BrewDog, Manchester, M2 5BG, Pedestrian visibility requirements

EAS Transport Planning Ltd has been appointed by Firstplan to provide highways advice in response to Manchester Highways Authority comments with regards to the pedestrian visibility at the site of, BrewDog Manchester, Peter Street, M2 5BG. A site location plan is contained at **Appendix A**.

Appendix C – Alternative Pedestrian Visibility Splays:

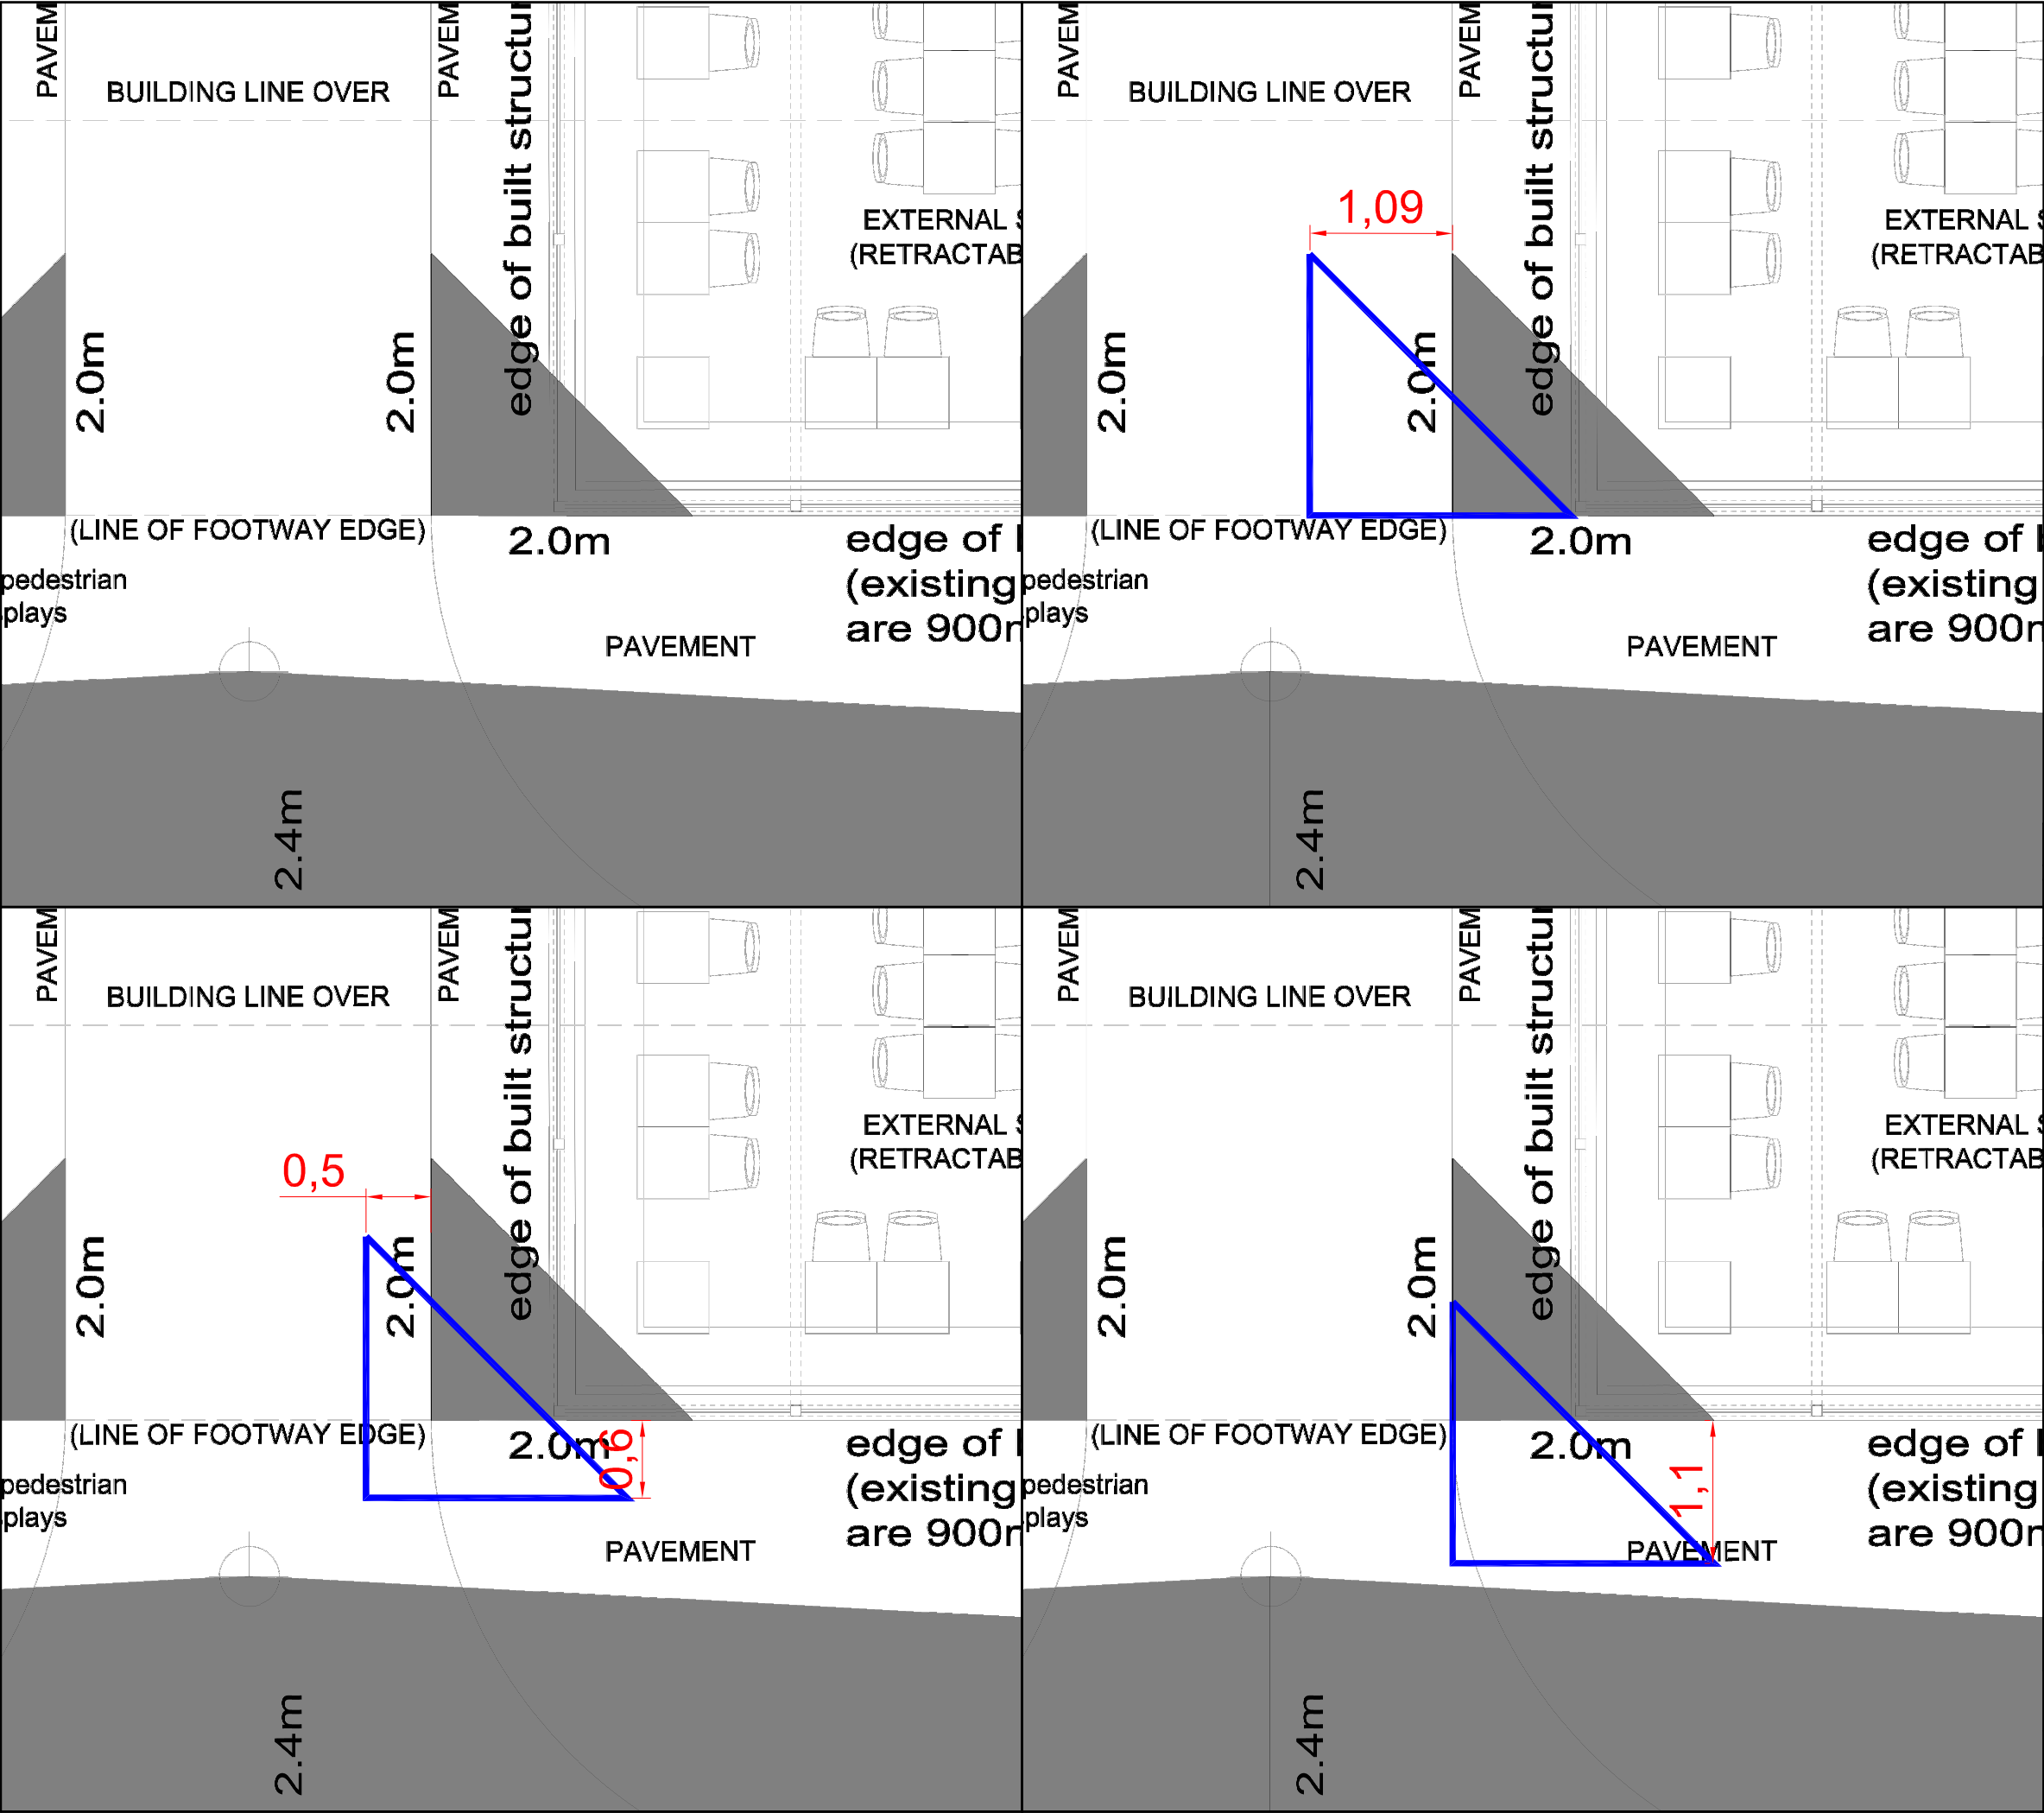
“my concern is driver view of crossing pedestrians when emerging from Marron Place, this is why I requested a 2m x 2m pedestrian visibility splay – but this has not been depicted on the plan provided. The plan should also show the retained footway width to makes sure enough clearance is provided so emerging vehicles don’t hit the structure when emerging/turning.”

With Manchester not having a formalised document stating pedestrian visibility a comparison can be made to highway authorities that do. 'Essex Highways Technical Manual' states a distance of 1.5m x 1.5m and Hertfordshire's emerging guidance 'Place & Movements' states a pedestrian visibility of 0.65m x 0.65m either side of the carriageway edge. Both splays forming part of official documents or emerging documents and offering reduced visibility splays compared to those highlighted by the Manchester Highway officer.

With Maldon Place being a narrow carriageway suitable for one vehicle at a time, it would be safe to assume vehicles would be traveling down the centre of the carriageway. If splays are measure from the centre of the carriageway they can comfortably be achieved even if pedestrians are walking along the edge of the wall. If the splays are illustrated 0.5m from the carriageway edge and 0.6m from the wall they can comfortably be achieved in both directions whilst still being reasonable in terms of vehicle placement on Maldon Place and Pedestrian desire line. All alternative pedestrian splay based on other design criteria have been contained at **Appendix C**.
